CITY OF CODY  
PLANNING, ZONING AND ADJUSTMENT BOARD  
TUESDAY, FEBRUARY 26 2013  
CITY HALL COUNCIL CHAMBERS @ 12:00 NOON

**CITY OF CODY  
PLANNING, ZONING AND ADJUSTMENT BOARD  
STAFF REPORT**

<b>MEETING DATE:</b>	FEBRUARY 26, 2013	<b>TYPE OF ACTION NEEDED</b>	
<b>AGENDA ITEM:</b>		P&Z BOARD APPROVAL:	X
<b>SUBJECT:</b>	CHAMBERLIN INN CONSERVATORY, DOWNTOWN ARCHITECTURAL DISTRICT REVIEW SPR 2013-03	RECOMMENDATION TO COUNCIL:	
<b>PREPARED BY:</b>	TODD STOWELL, CITY PLANNER	DISCUSSION ONLY:

<b>MEETING DATE:</b>	FEBRUARY 26, 2013	<b>TYPE OF ACTION NEEDED</b>	
<b>AGENDA ITEM:</b>		P&Z BOARD APPROVAL:	X
<b>SUBJECT:</b>	SITE PLAN REVIEW: BAKER HUGHES ADDITION SPR 2013-07	RECOMMENDATION TO COUNCIL:	
<b>PREPARED BY:</b>	TODD STOWELL, CITY PLANNER	DISCUSSION ONLY:

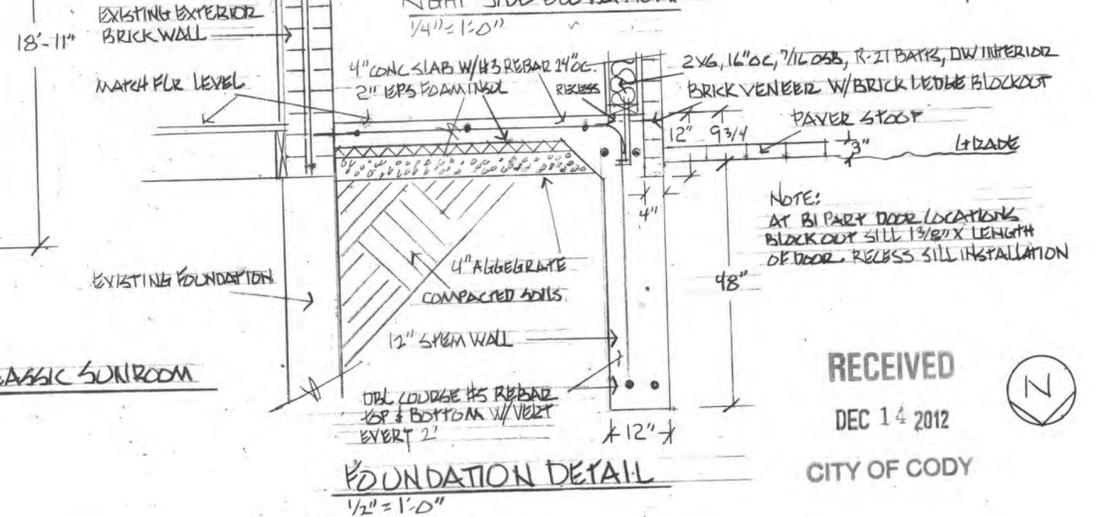
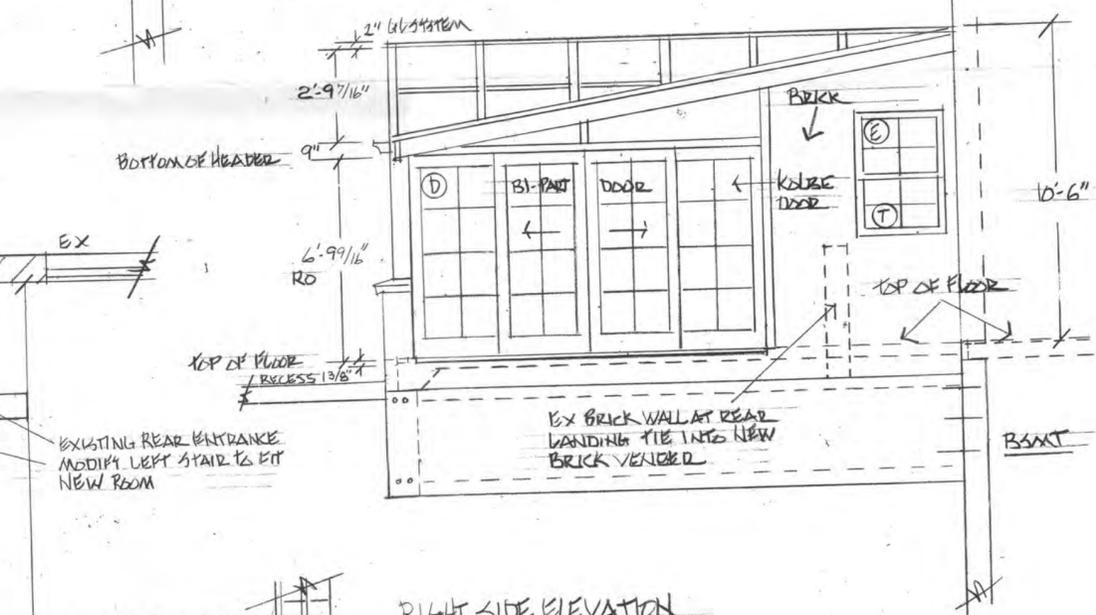
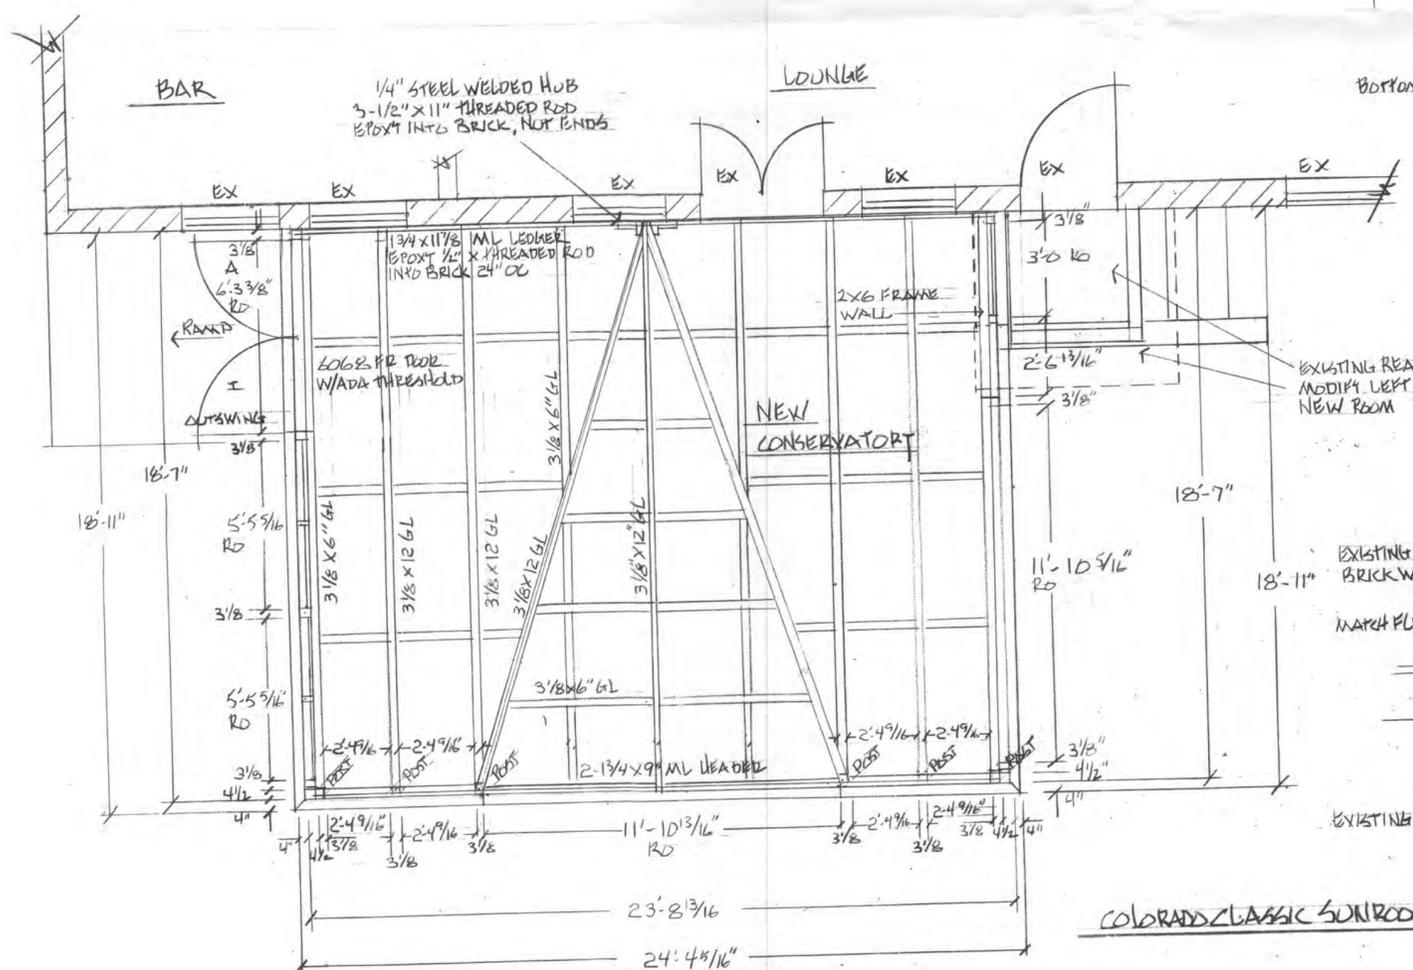
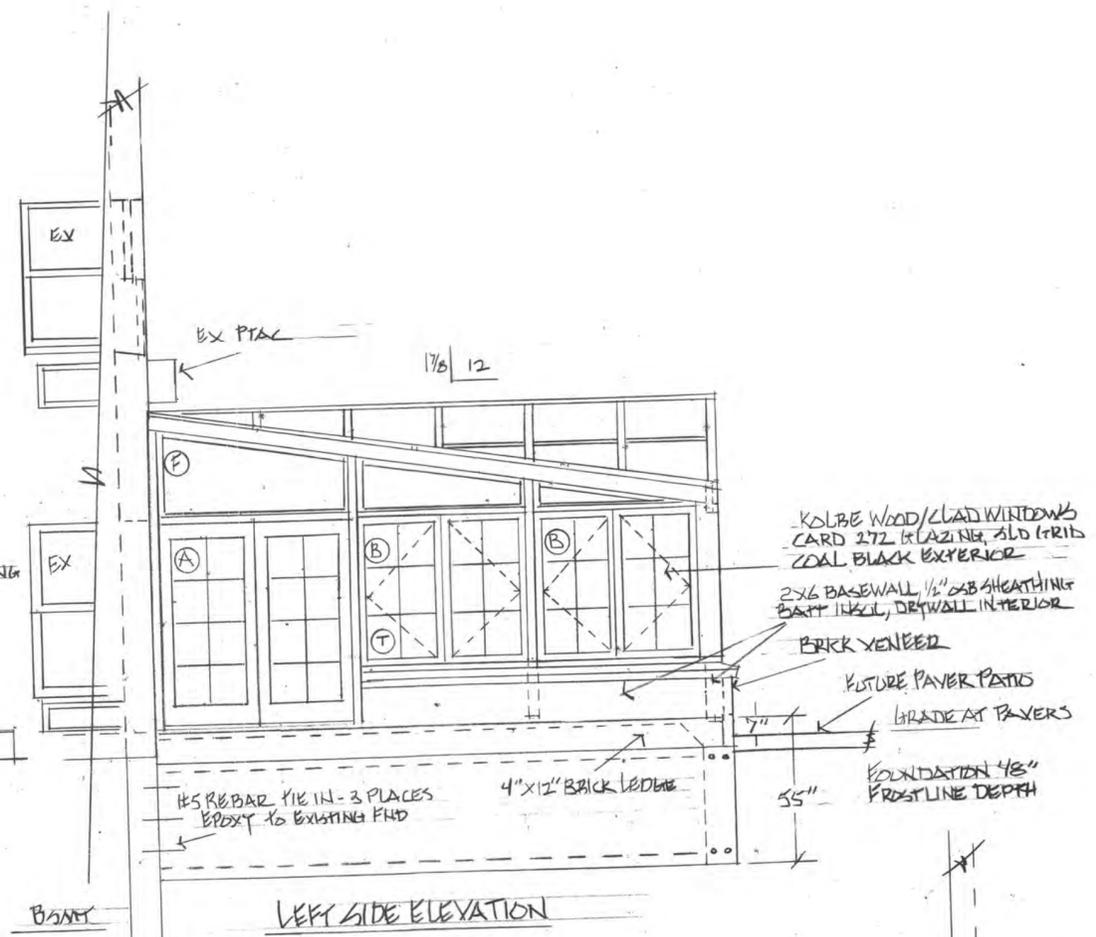
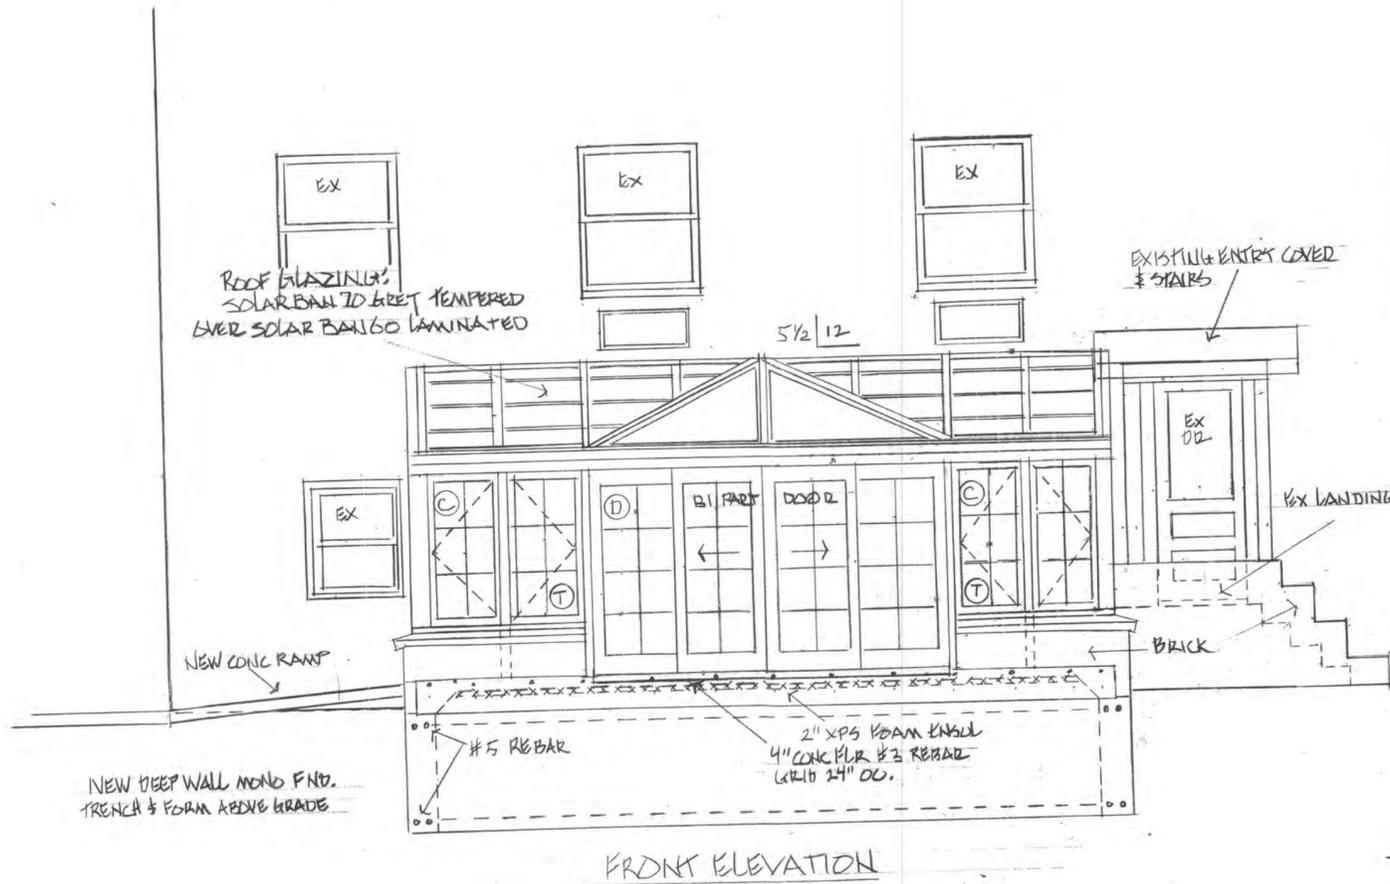
The building plans and elevations for the sunroom are attached. It is a wood-framed glass structure, with brick, brick veneer, and wood clad windows. The colors are not indicated in the application, so the applicant will need to confirm if they match the existing brick and trim colors, or an alternative compatible color scheme. Looking at

sunrooms on the manufacturer's website (coloradoclassicsunrooms.com), their work is high-quality, attractive, and appears to match well with the architecture of the Chamberlin Inn. Provided the color scheme matches the existing building, staff has no concerns regarding the architectural components of the project.

No exterior lighting is indicted on the plans. If lighting is added, it should be of a full cut-off or shielded design.

Approve the installation of the conservatory/sunroom subject to the following:

1. That the building permit only be issued after the property is exempted from providing any additional parking through adoption of the pending parking ordinance, or the parking is waived through the appropriate variance/special exemption process.
2. That use of the sunroom maintains compliance with any applicable liquor license requirements.
3. That any exterior lighting be of a full-cut off design or shielded.
4. That the project must otherwise comply with the submitted site plan and applicable building, fire, and electrical codes. A building permit application is required.

**SITE PLAN  
BUILDING ADDITION**  
DEVELOPER  
ED HIGBIE  
CODY, WY 82414  
LOTS 5 & 6  
C.H.I. INDUSTRIAL PARK  
CITY OF CODY, PARK COUNTY, WYOMING

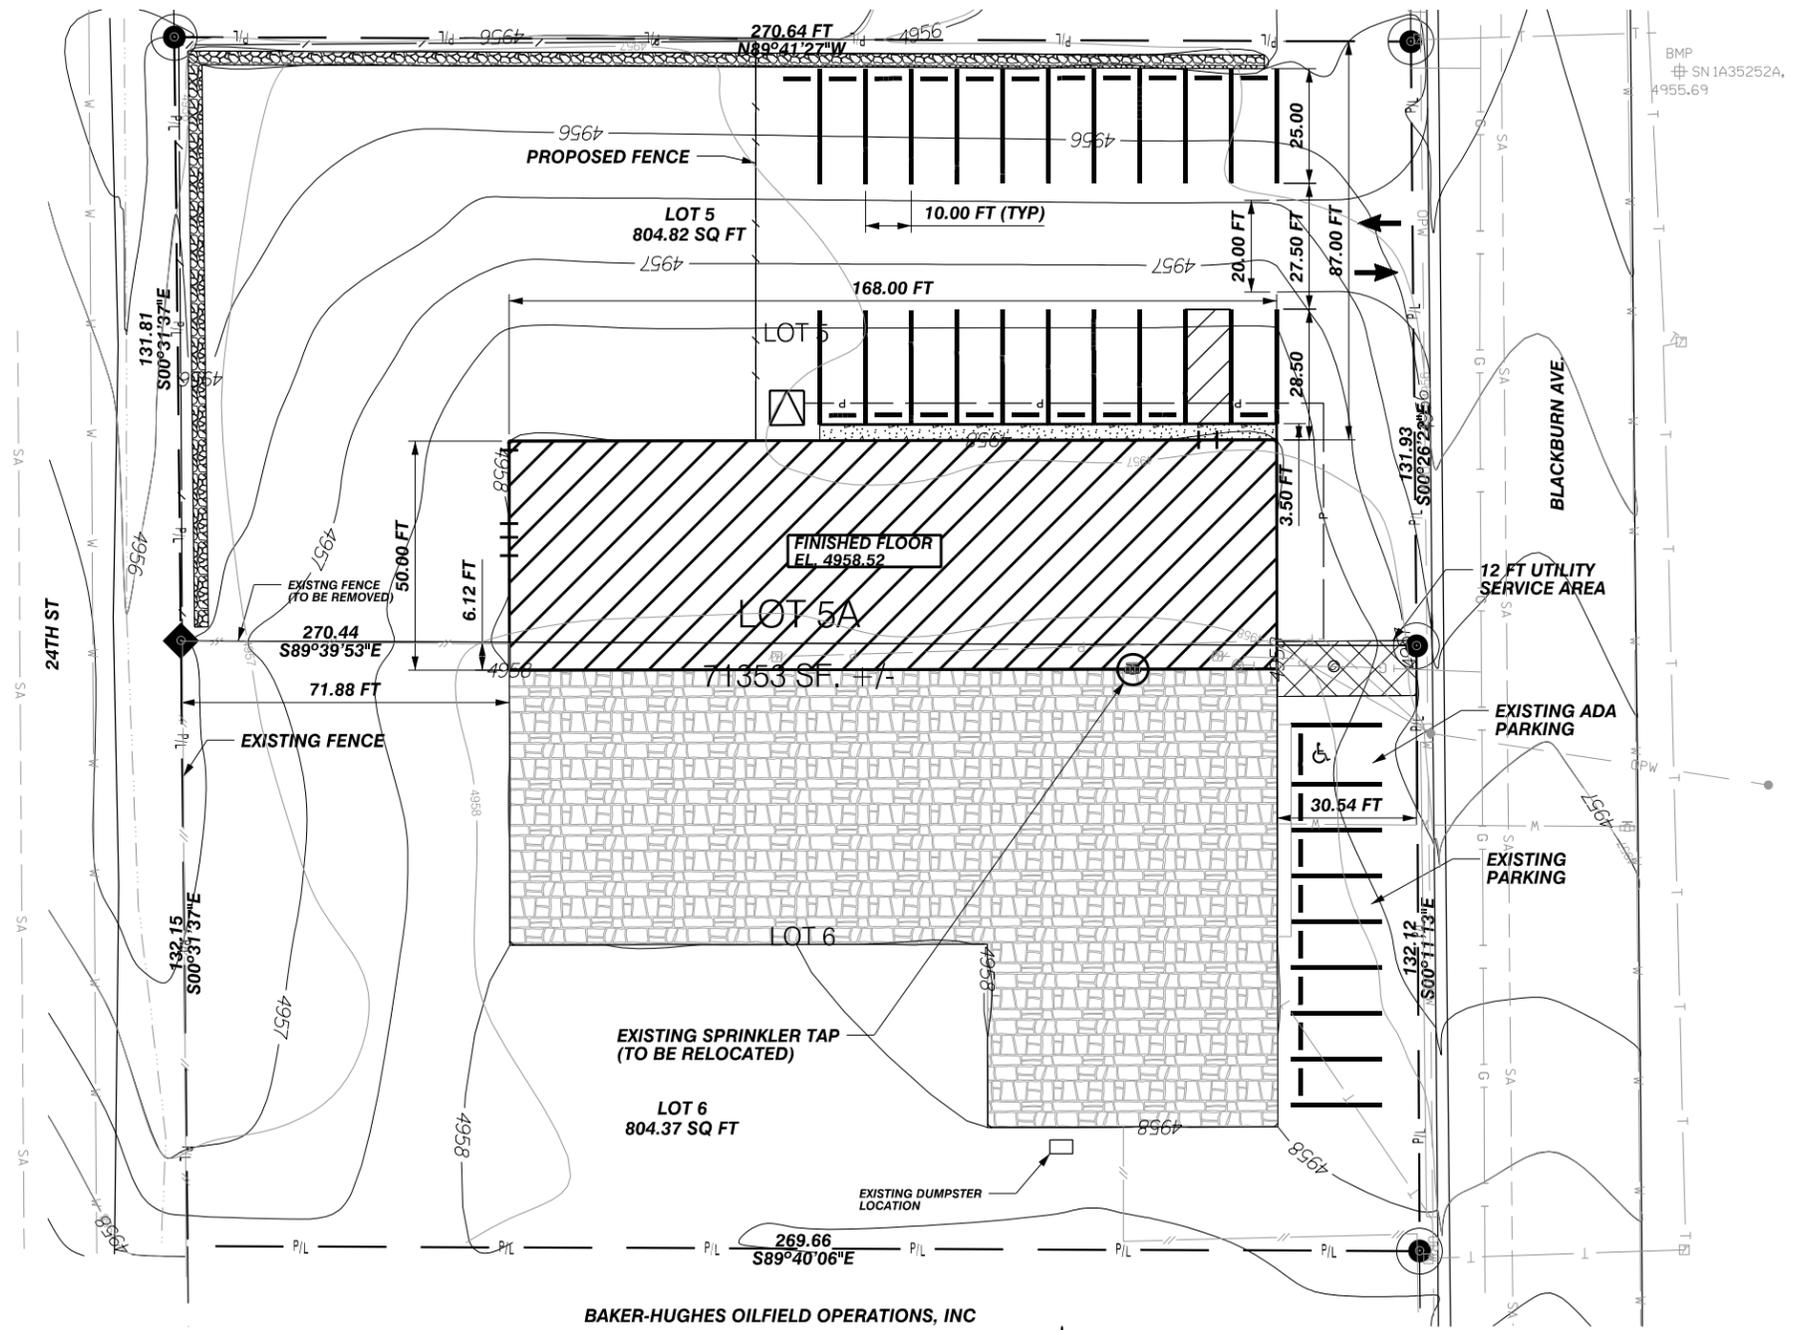
The parking ordinance requires industrial uses to provide one space per employee plus one space per average number of customers expected at any one time. The existing site has about nine spaces along Blackburn Avenue, which appear to typically accommodate existing parking needs. The site plan adds twenty new spaces, and the site can easily accommodate more. The parking area will be graded for storm water purposes and may be paved at some time, but will be gravel initially.

The plans show a single existing ADA parking space. As more than 25 spaces are now provided, a second ADA space is required. The details of the ADA spaces must be provided with the building permit application.

Exterior lighting locations are not indicated on the plan, but described as being over the entryways and on the north side of the building, in order to shine onto the parking lot from the building. The exterior lighting should be of a down-lit style, so that light is not directed beyond the property lines. A full-cut-off, forward throw style will function for the parking area.

However, there is an existing property line between the existing building and proposed addition. To avoid firewall separation requirements the property owner has submitted an application to remove the property line.

The area along the north property line, over the percolation trench, is identified as the snow storage area.

No sidewalks are proposed along Blackburn Street. Power poles, landscaping, and gravel characterize much of the west side of Blackburn Street, although sidewalks are almost continuous along the east side of Blackburn Street. Whether sidewalks are required for this project or not, it should specifically be noted.

If the Planning and Zoning Board is agreeable to approving the application, it is recommended that it be subject to following.

1. That details of the roof drainage be submitted no later than at the time of building permit review, for approval by the Building Official and City Engineer upon demonstration that storm water from the middle of the roof will flow to the west as proposed, or otherwise be directed to the infiltration trench.
2. That prior to issuance of a building permit, the lot line must be removed or relocated.
3. That the storm water facilities be inspected and certified by the applicant's engineer prior to building occupancy.
4. That any exterior lighting be of a down-lit style.
5. That a second ADA parking space and loading area be provided in accordance with ADA standards.
6. That the project must otherwise comply with the submitted site plan and applicable building, fire, and electrical codes. A building permit application is required.
